TITLE: **AP1000 DCD Impacts to Support COLA Standardization**

**APP-GW-GLR-134**  
**Revision 0**

# **AP1000 Standard Combined License Technical Report**

## **AP1000 DCD Impacts to Support COLA Standardization**

Figure 3I.1-2

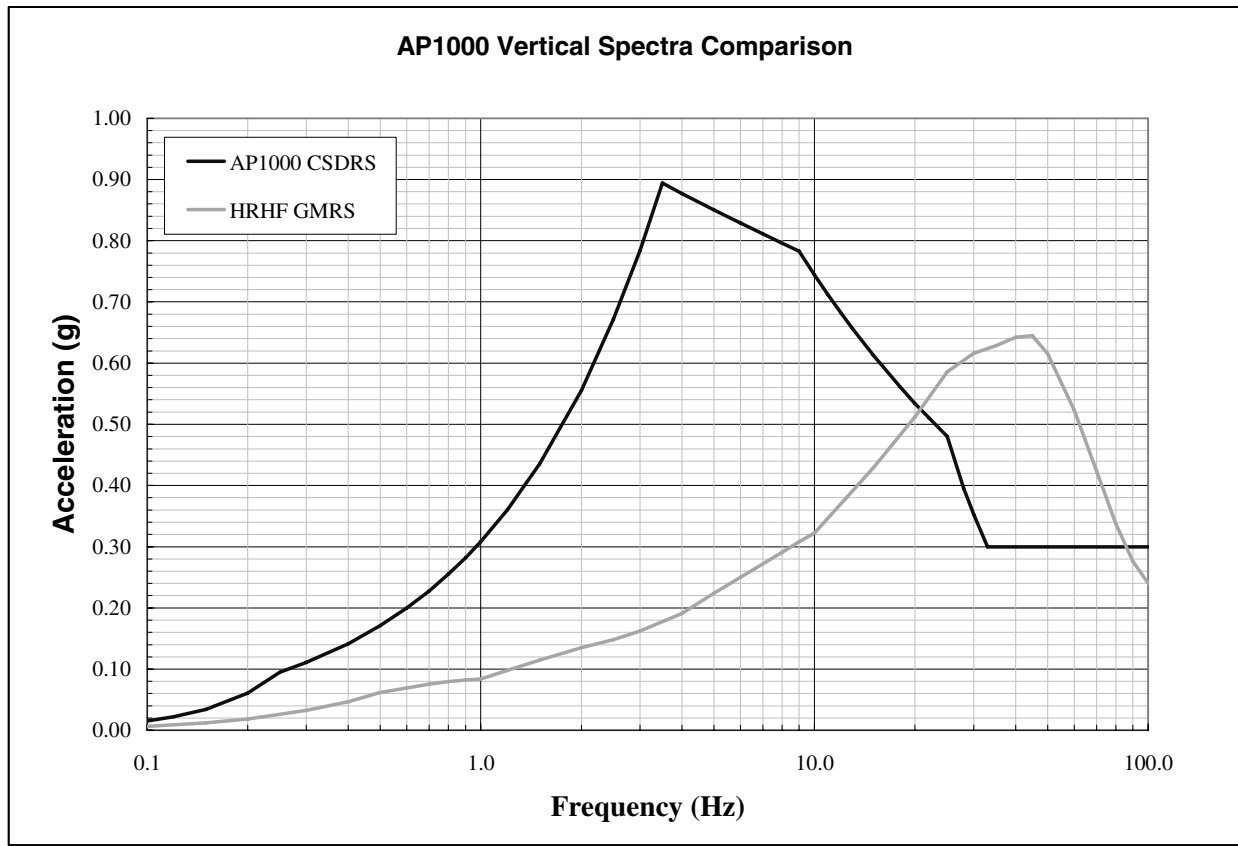
NRC 163

Figure 7.2-1 (Sheet 20 of 20)

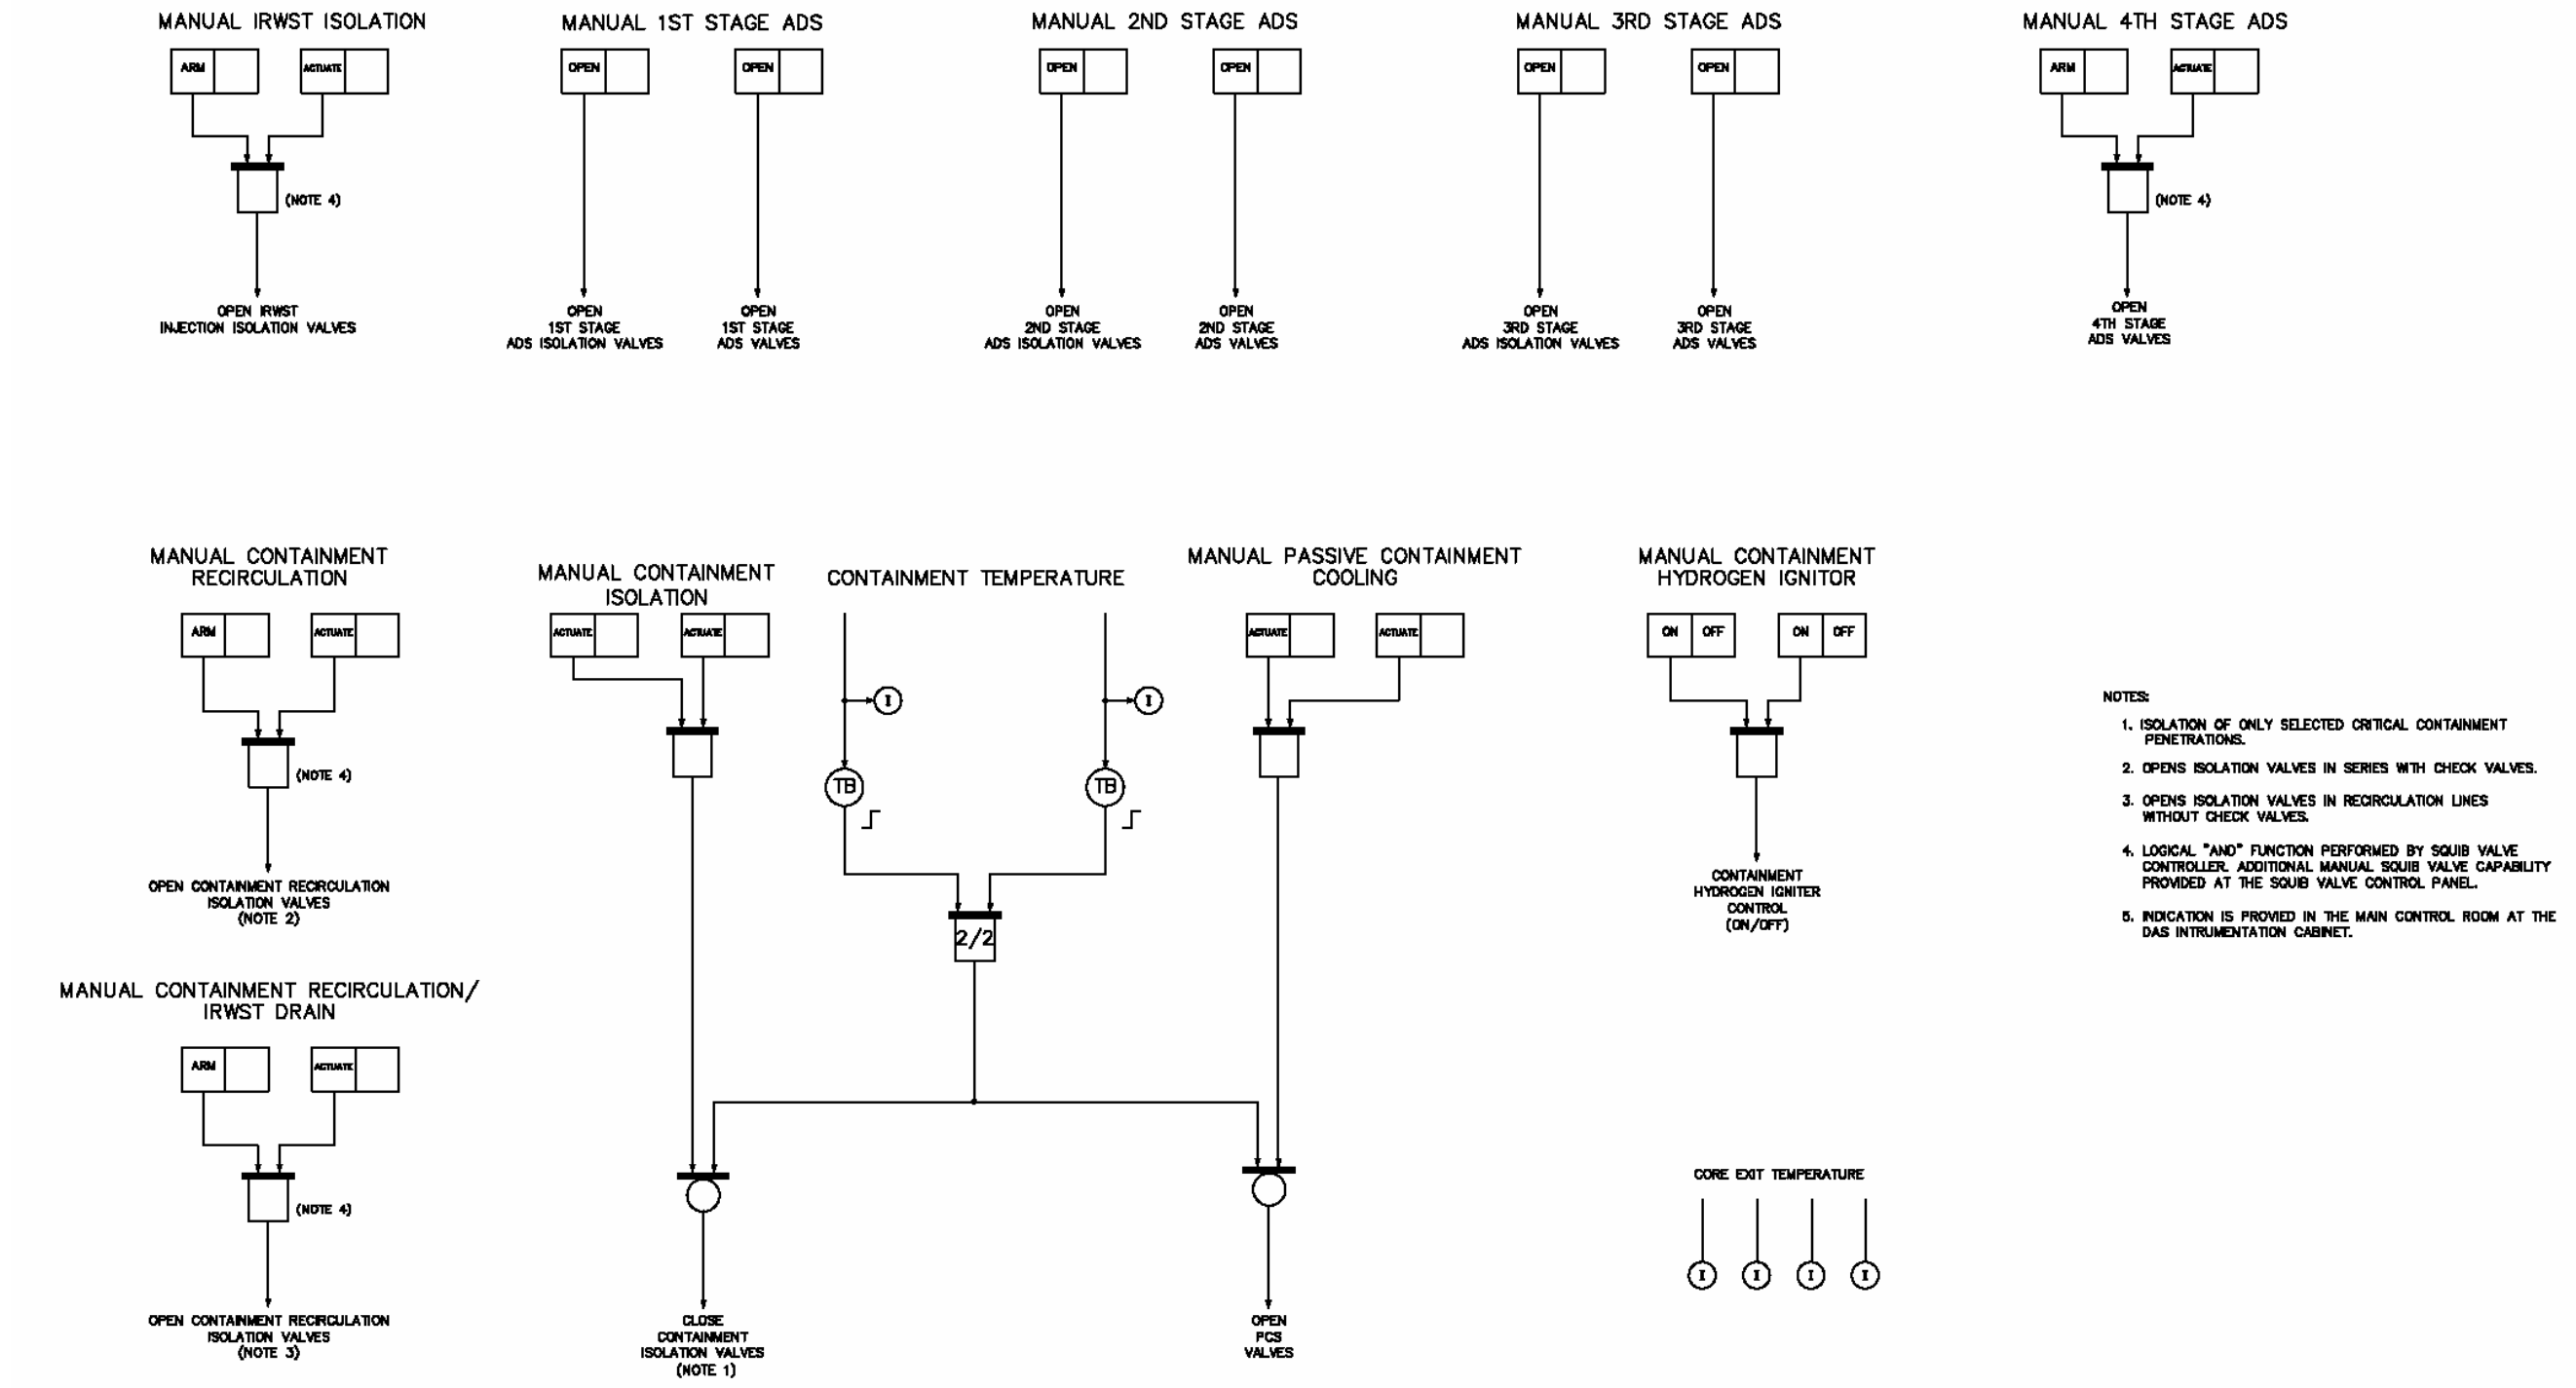
**NRC 138 has changes to the notes of Figure 7.2-1 (sheet 20 of 20) to be consistent with RAI-TR97-ICE-03.**

Figure 9.5.4-1 (Sheet 2 of 3)

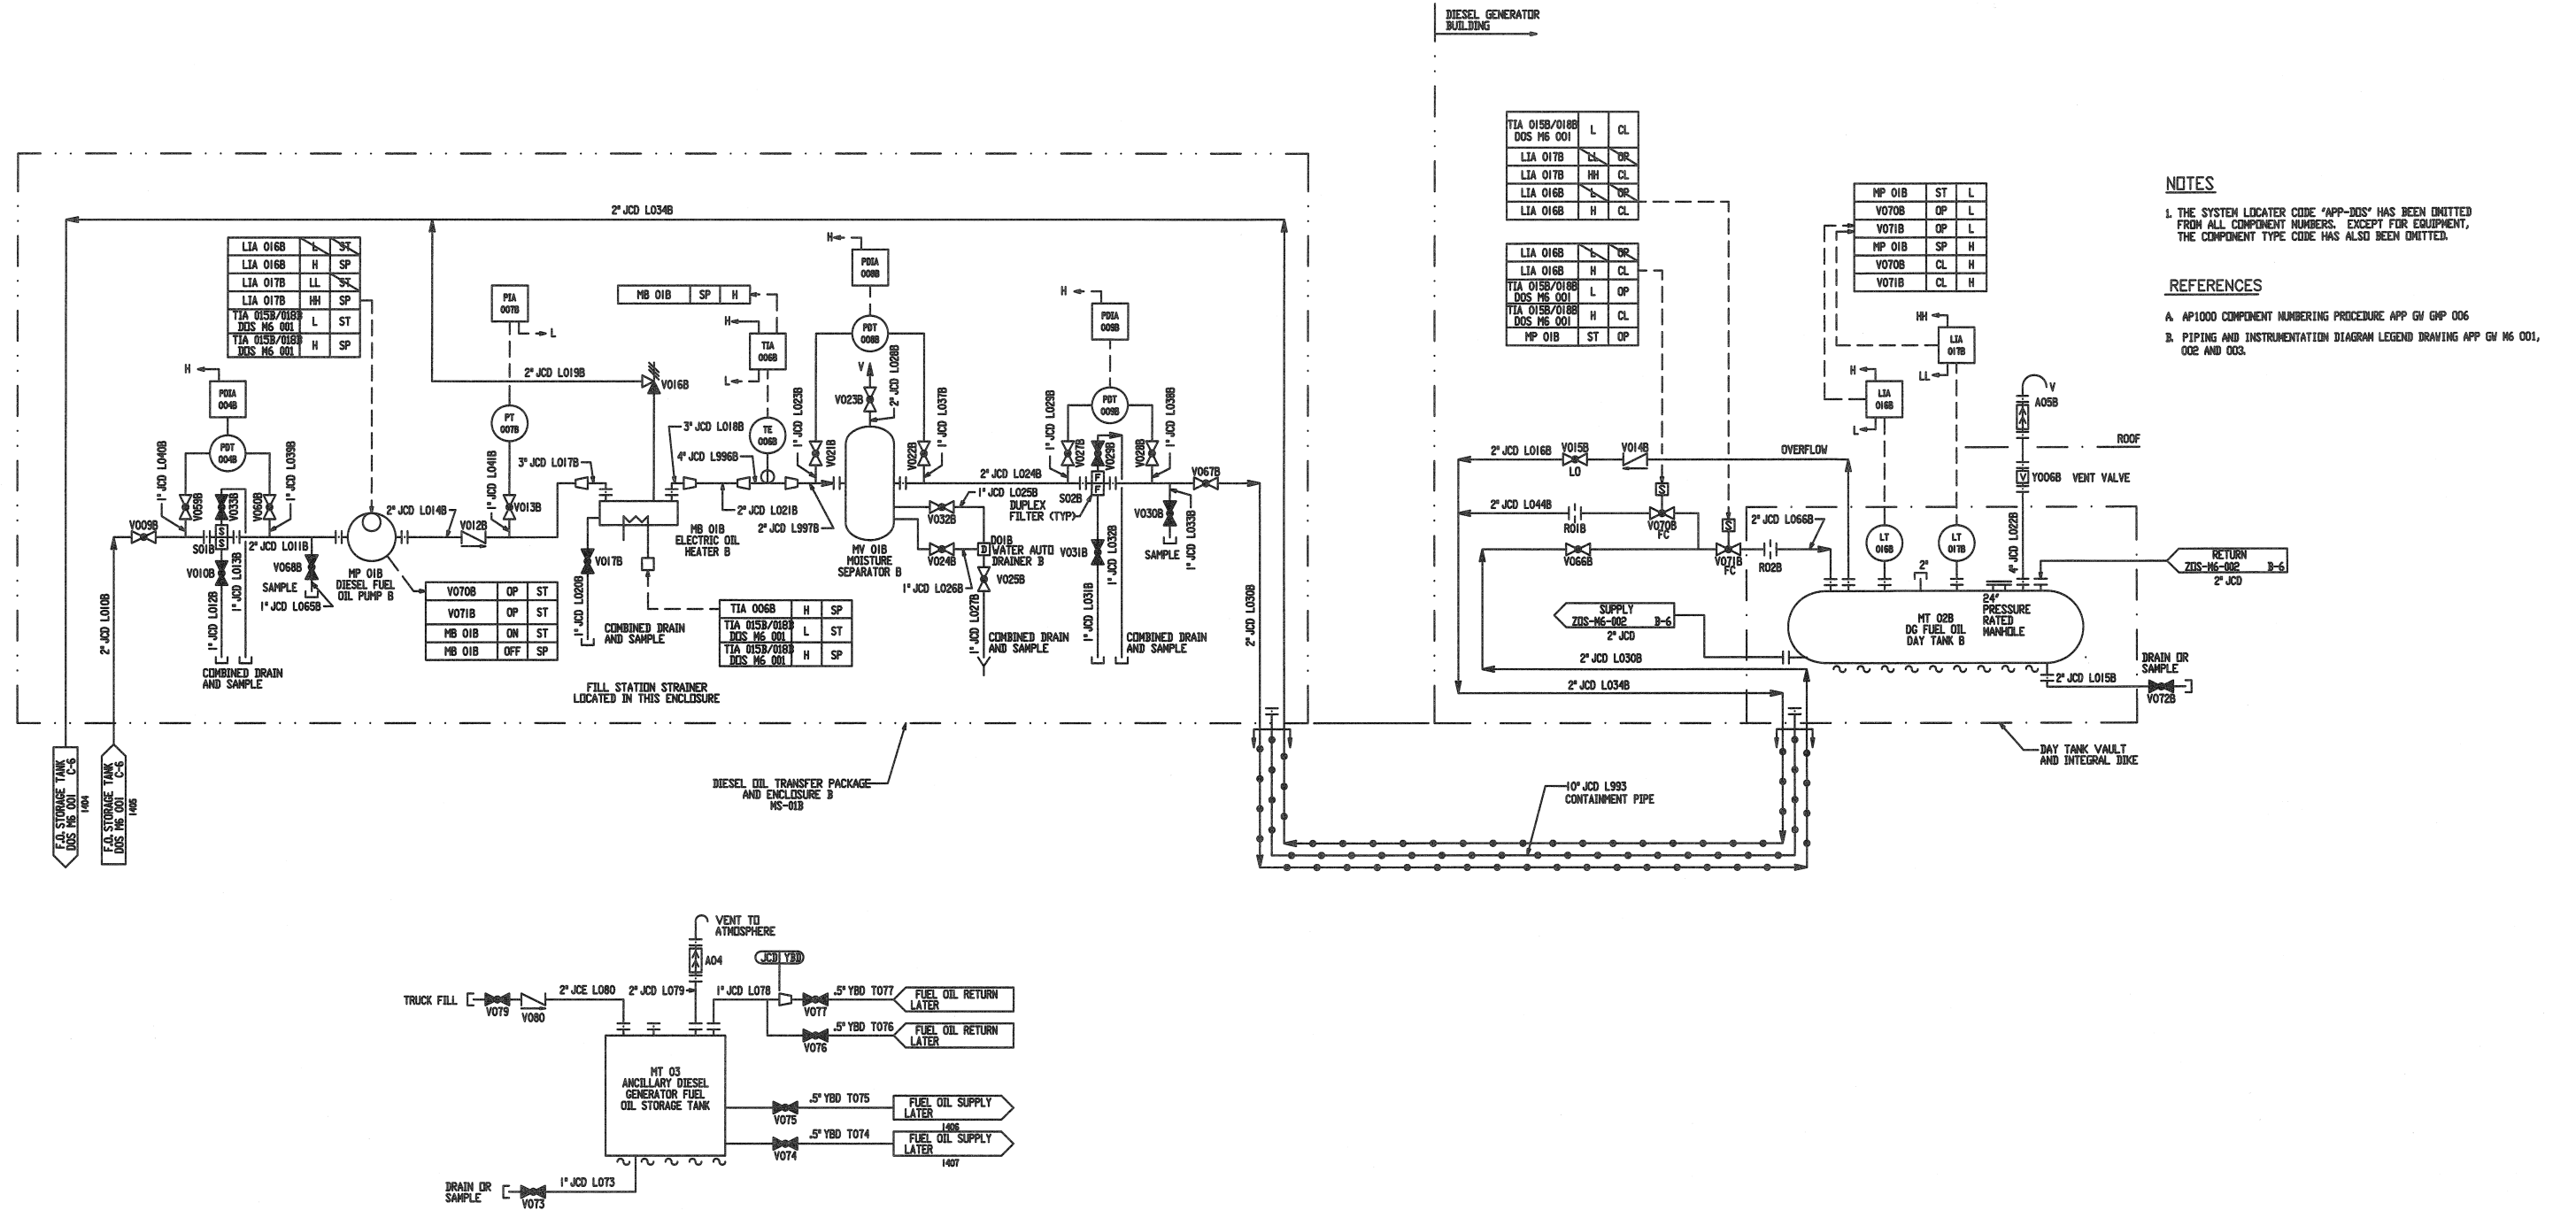
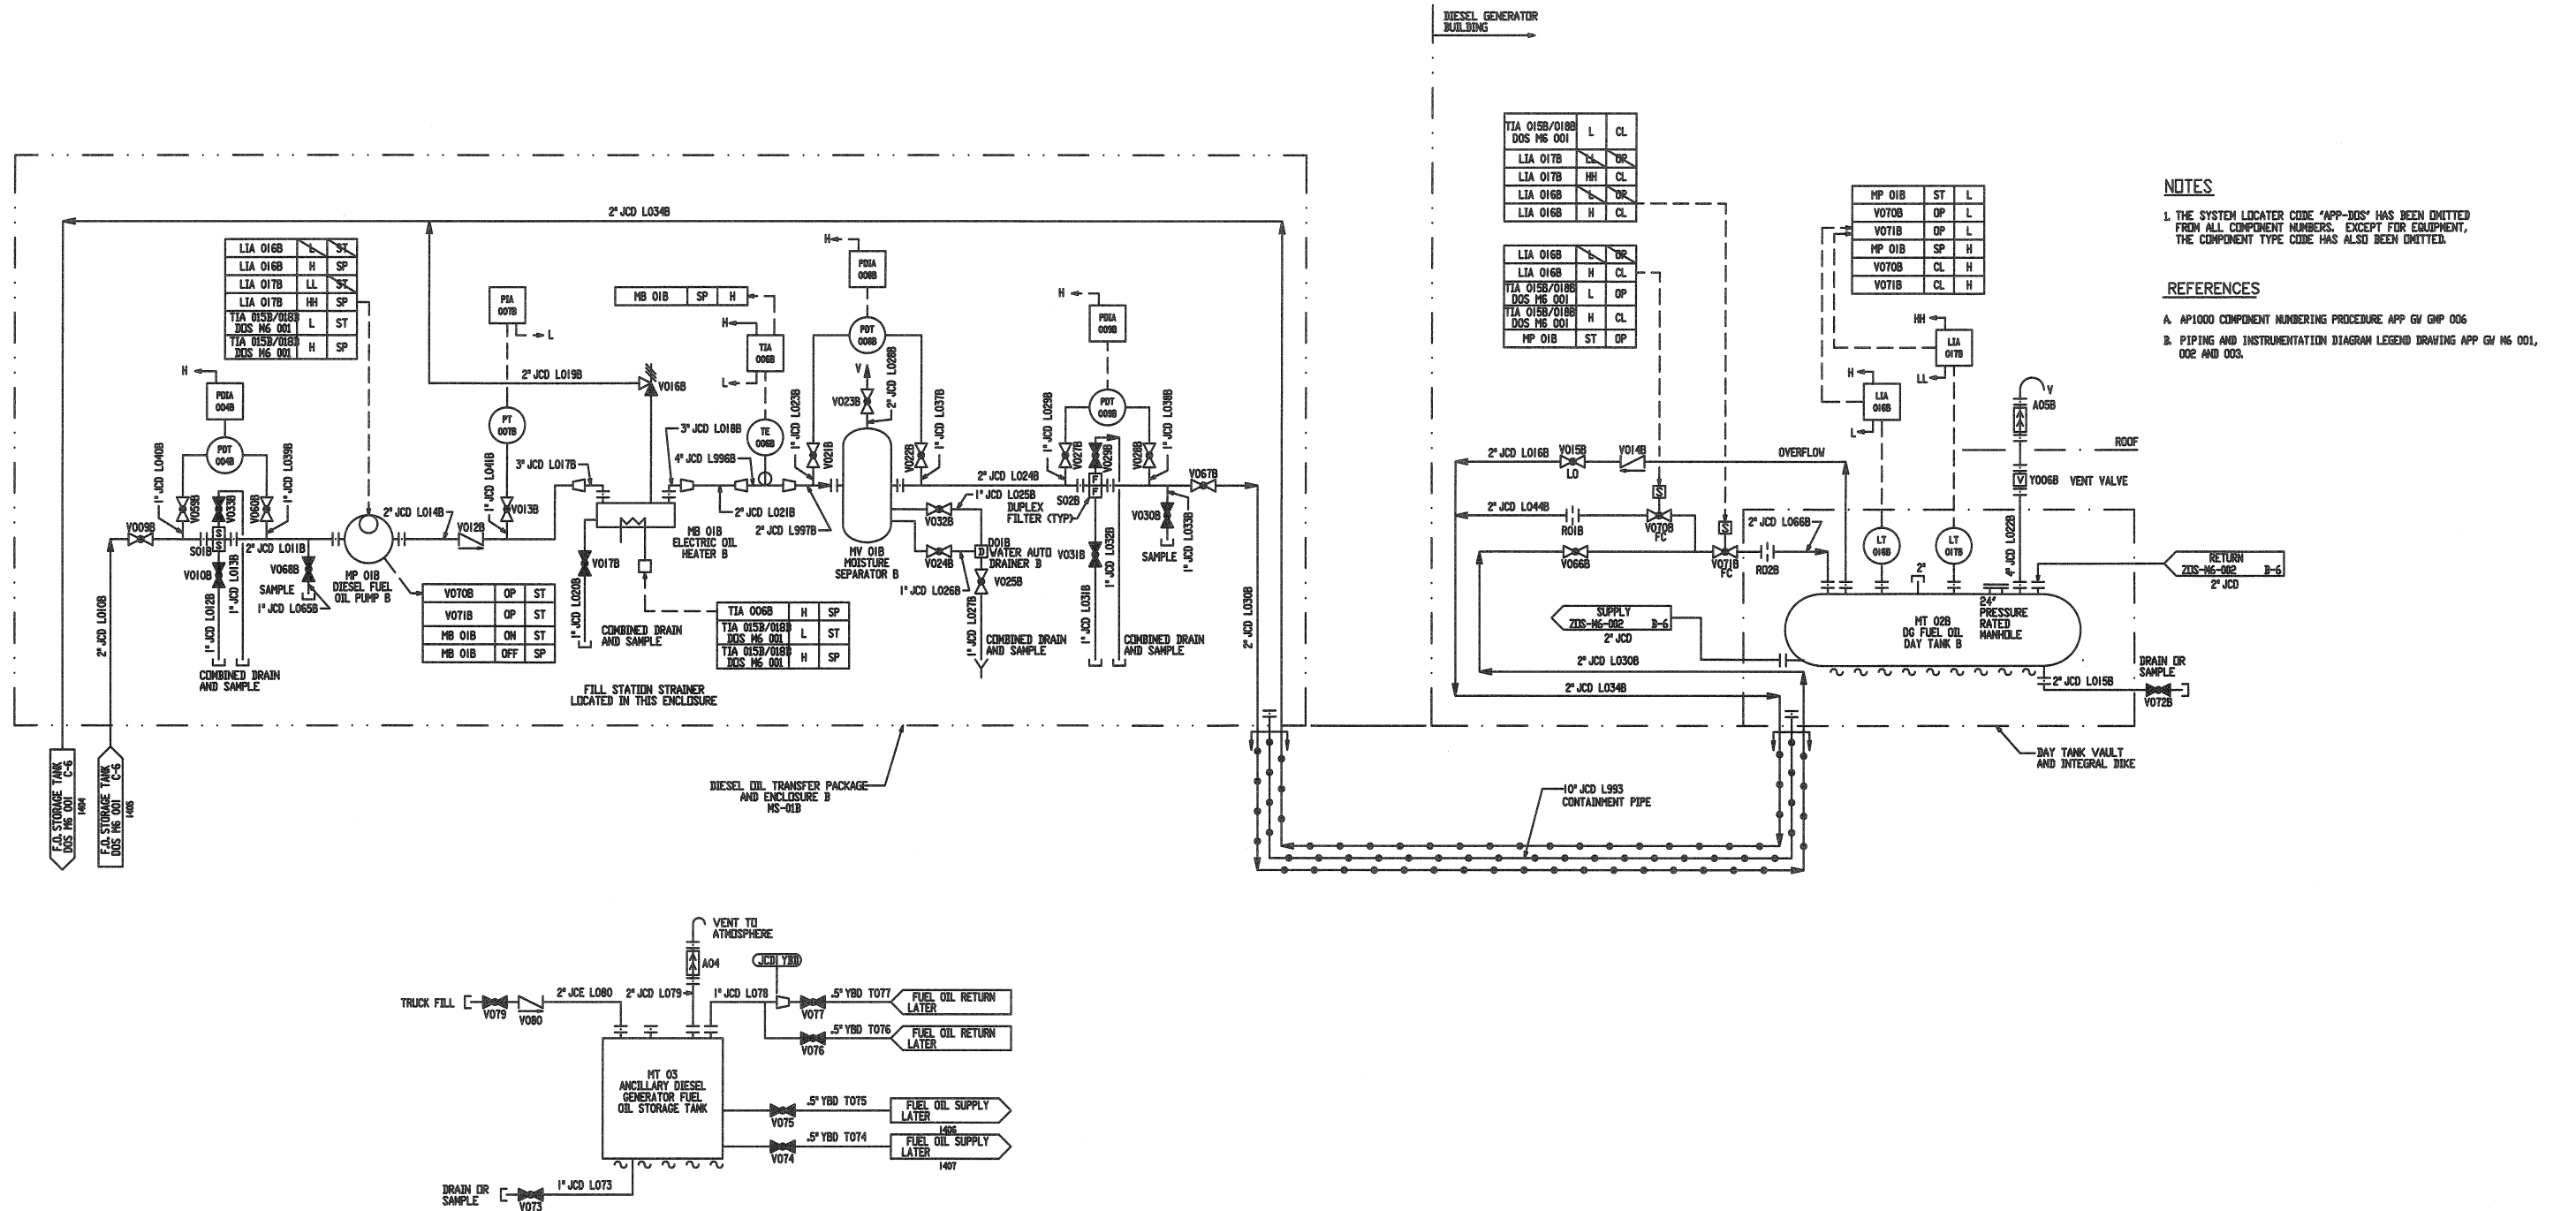
**NRC 072 contains changes to Figures 9.5.4-1 (Sheets 1, 2, and 3) of the DCD Revision 16 to delete Auxiliary Boiler out of the title.**
